ADDENDUM NUMBER 2

PROJECT: Former Marquette General Hospital Campus

FROM: Northern Michigan University Foundation

ISSUE DATE: January 23, 2023

Attachments(2): Figure: City of Marquette – Engineering Department, Water and Sewer Infrastructure

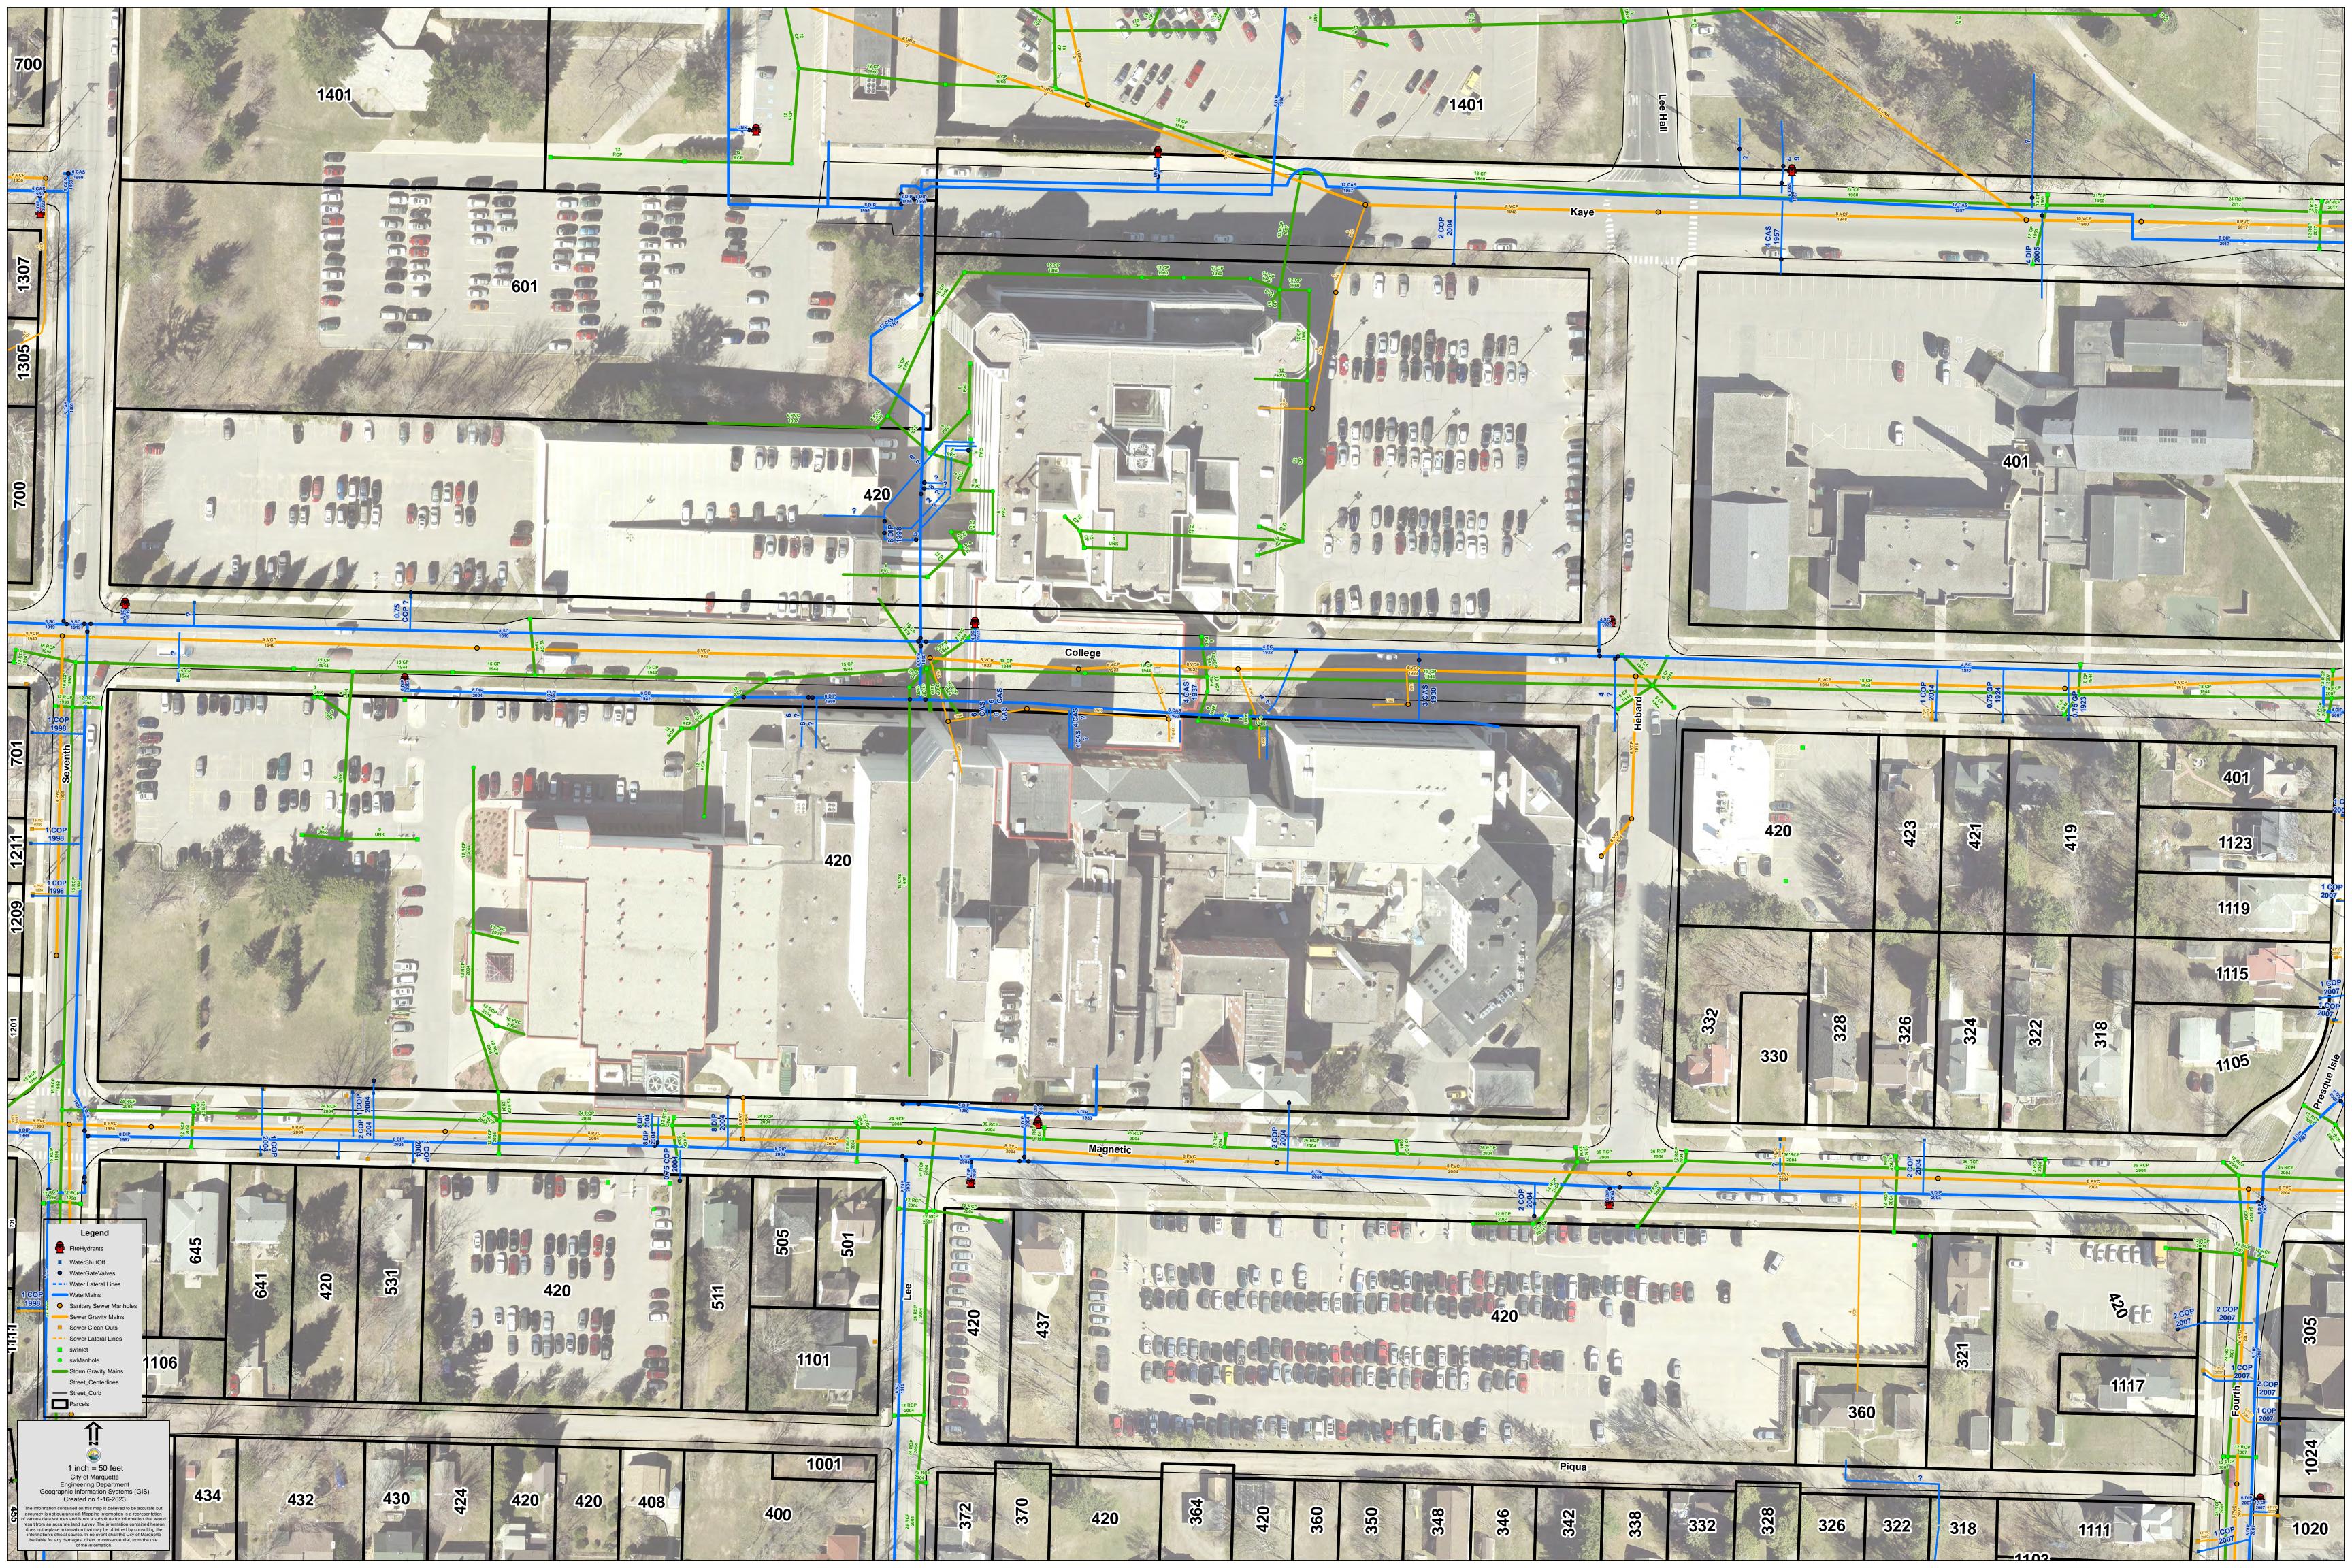
"Per the City of Marquette, Engineering Department, Water services with less than 2" diameter can be abandoned at the ROW. Larger diameter services should be abandoned at the main, or a hydrant installed at the end of the lead to allow for proper flushing. EGLE does not permit dead end water mains that cannot be flushed. All storm and sanitary abandonments can be completed at the ROW.

A figure showing the water and sewer mains and laterals is the vicinity of the project area is attached to this Addendum.
